GW - 80

**GENERAL
CORRESPONDENCE**

STATE OF
 NEW MEXICO
 OIL
 CONSERVATION
 DIVISION

**RE: GROUND WATER ANALYSES
ENRON THOREAU COMPRESSOR STATION
MCKINLEY COUNTY, NEW MEXICO**

Figure 23

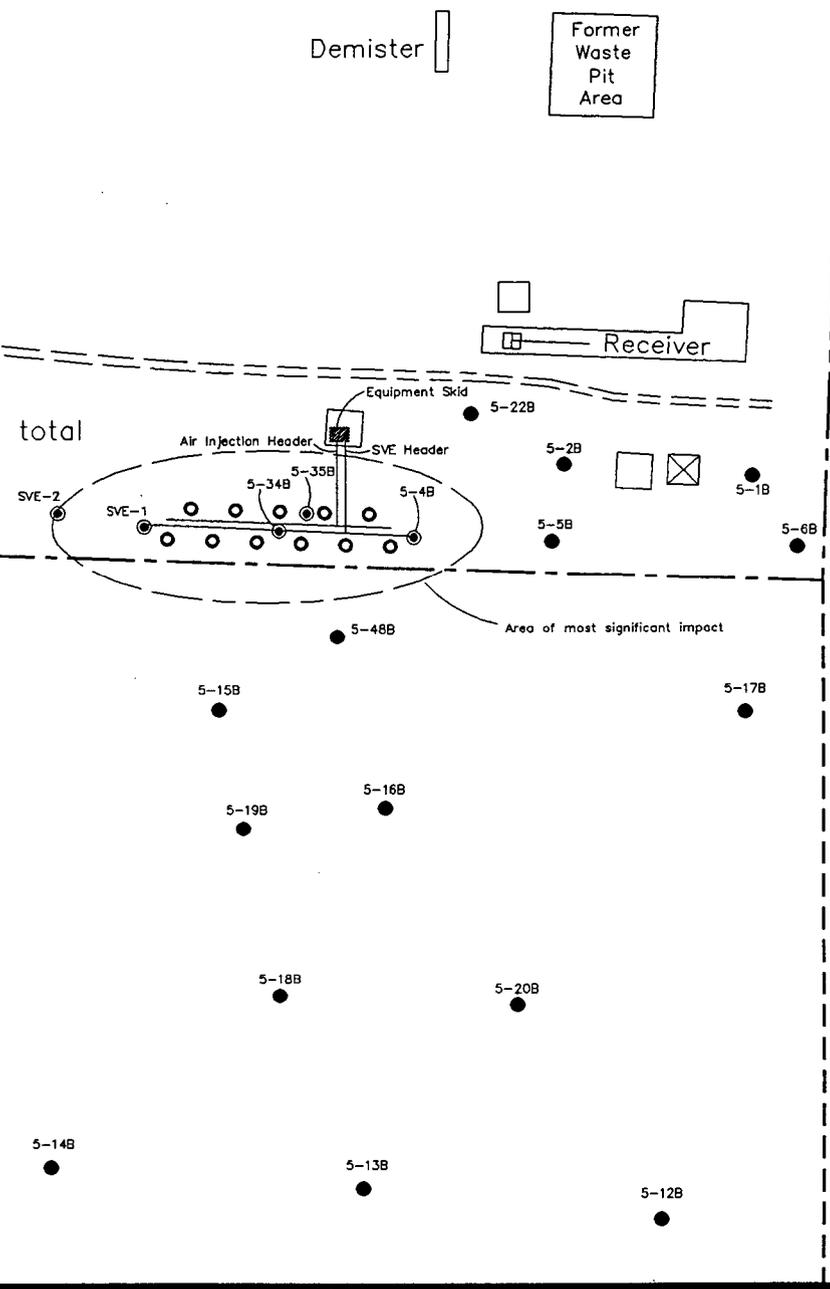
3. ENRON has amended its Phase II and Phase III plans (see attached modified figures, Figures 23 & 27) to include the installation of two additional SVE wells during implementation of the Phase II system. The well designated SVE-1 will be located approximately 75 feet west of 5-34B and the well designated SVE-2 will be located approximately 130 feet west of 5-34B. During operation of the Phase II system, SVE-1 will be utilized as an extraction well and SVE-2 will be utilized only as an observation and ground water monitor well. During operation of the Phase III system, both SVE-1 and SVE-2 will be utilized as extraction wells.
